In Reply Refer To:
HSST-1/CC-126C

- MSKT- SP-MGS (MASH Sequential Kinking Terminal, Standard Posts, Midwest Guardrail System) with Wood Posts.

MSKT-MGS-W
Terminal
Test Level 3

Wood-Post MSKT System Product Description

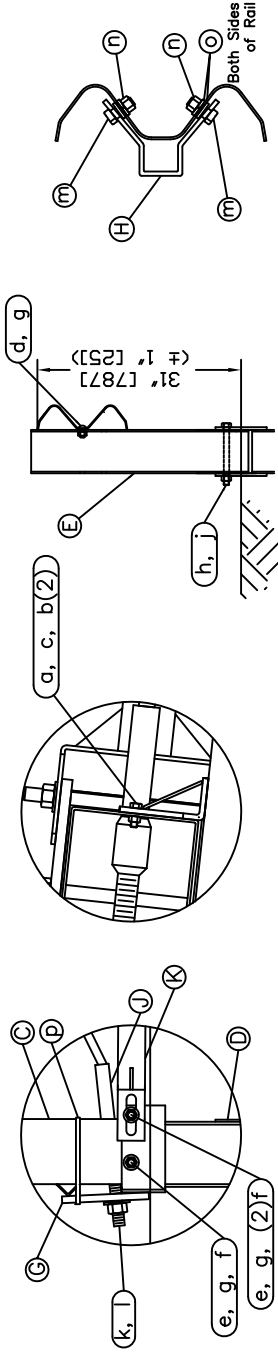
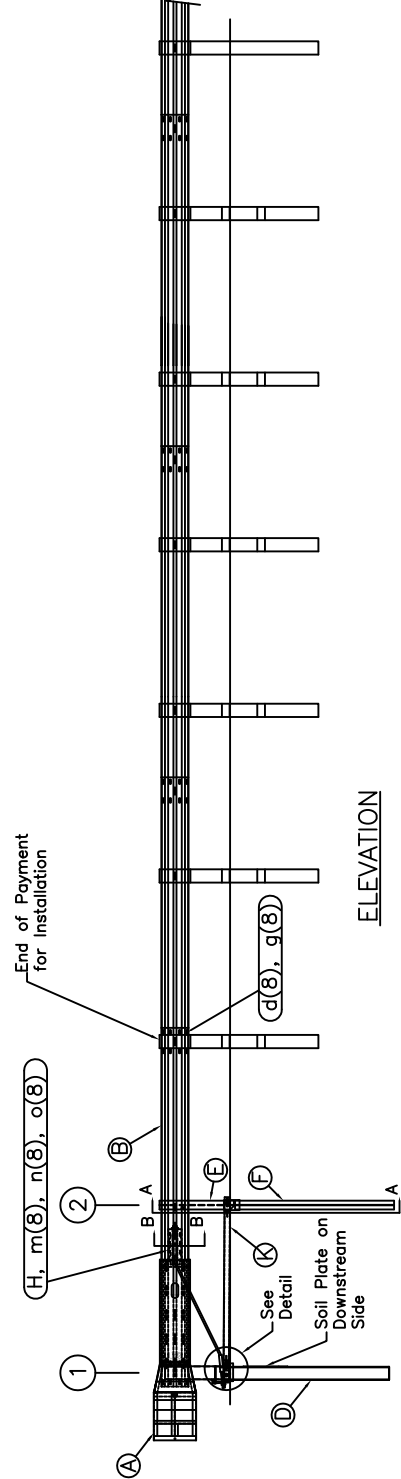
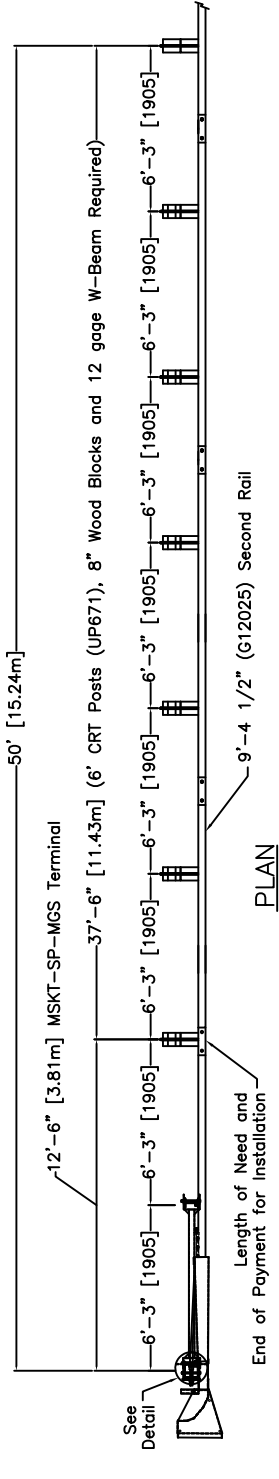
1. Use of CRT wood posts in post locations 3 through 8.

Figure 1 shows a schematic drawing of the wood-post MSKT terminal. The wood-post system uses the same SP anchorage system, i.e., the same steel posts 1 and 2 with a ground strut, as the steel-post system. Posts 3 through 8 are CRT (Controlled Release Terminal) wood posts, and standard wood line posts are used from post 9 and beyond. Other than the posts, the other components of both MSKT systems are the same.
